MetroLink - Module 1

1. Tunnelling, Excavation Related Issues (Groundborne Noise & Vibration, Hydrogeological and soils impacts, settlement, property damage)
2. Airborne Noise & Vibration

Witness Statement by [Brian Kavanagh of GARLAND] on Behalf of Charlemont & Dartmouth Community Group in relation to [Building Settlement]

This statement relates to building settlement and principally concerns impacts upon Dartmouth Road properties 26-28 and 32-35 and Dartmouth Square West nos. 1, 3, 5, 7, 9, 10, 11, 12, 13, 14, 15, 16.

(Extract from Drawing ML1-JAI-EIA-ROUT_XX-DR-Y-21147)

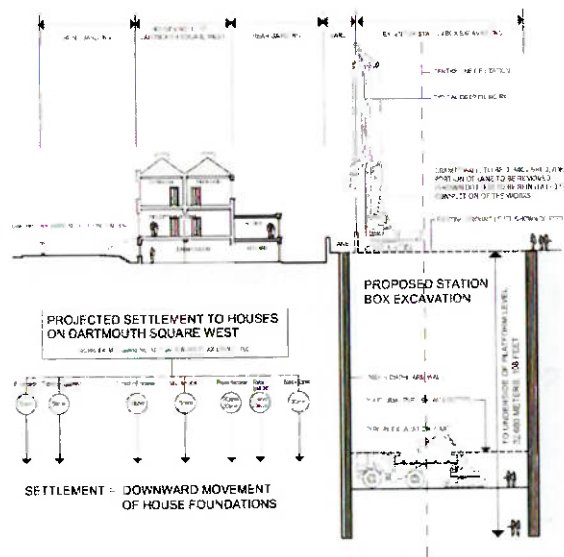
TII Building Damage Section (Appendix 5.19) has predicted “conservative” settlement figures in the area of the Charlemont Station / Turnback In the order of

30mm Rear of Dartmouth Walk / Square West

10mm Front of Dartmouth Walk / Square West

45mm Front of Dartmouth Road

35mm Rear of Dartmouth Road

We refer to the revised predicted settlements reproduced below.

However, these settlements are based on a “rectangular” station box. In fact, the actual extent of the station is considerably more, see extract from drawing below.

A review of the EIAR and associated appendices, it is evident that a very limited assessment of settlement and subsidence has been carried out. It can be seen from the above diagram that the houses directly over the tunnels on Dartmouth Road fall within the 35mm to 45mm settlement zone. This is defined as “slight” risk category. We would query this classification as “slight”. However, given that all but one of the buildings covered by this submission are protected structures, they should be classed as damage category risk 3 (moderate) or 4 (severe). We will discuss this later.

DEEP EXCAVATION, PROJECTED SETTLEMENT TO HOUSES AT DARTMOUTH SQUARE WEST

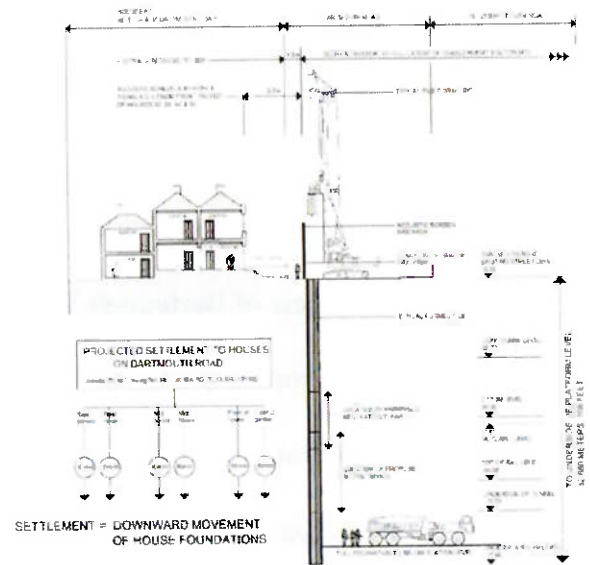
SETTLEMENT OF 30mm PROJECTED FOR HOUSES AT DARTMOUTH SQUARE WEST

- A. EXTREME DEPTH OF EXCAVATIONS - SETTLEMENT CONCERN
B. PROXIMITY OF CONSTRUCTION PILING RIGS AND PILES - VIBRATION AND SETTLEMENT CONCERNS
C. PROXIMITY OF METRO TUNNEL AND STATION BOX - VIBRATION AND SETTLEMENT CONCERN
D. SEE ALSO ACCOMPANYING COLOURED CONTOUR PLAN PROJECTED SETTLEMENTS

DEEP EXCAVATION, PROJECTED SETTLEMENT
TO HOUSES AT 32 TO 35 DARTMOUTH ROAD

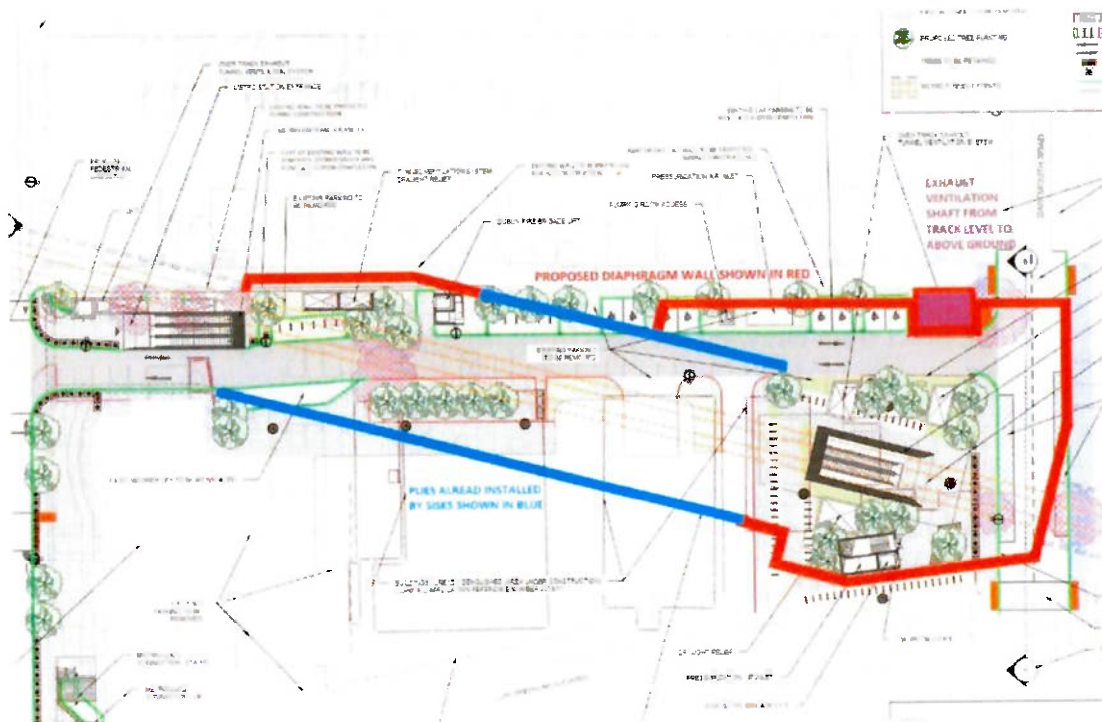
SETTLEMENT OF 45 MT PROJECTED FOR HOUSES 32 TO 35 DARTMOUTH ROAD.

- A. EXTREME DEPTH OF EXCAVATIONS - SETTLEMENT CONCERNS
- B. PROXIMITY OF CONSTRUCTED DRILLING RIG AND PILES - VIBRATION AND SETTLEMENT CONCERNS
- C. PROXIMITY OF RETRO TUNNEL AND VENTILATION TUNNEL - VIBRATION AND SETTLEMENT CONCERNS
- D. REINFORCED FOOTPATH - REDUCED TO 3 IN. FOR 8 YEARS - DARK UNSAFE
- E. FACTORS - HEIGHT OF REARLIFT AND STRENGTHENING OF HIGH FOR 8 YEARS - CURE REPAIRS
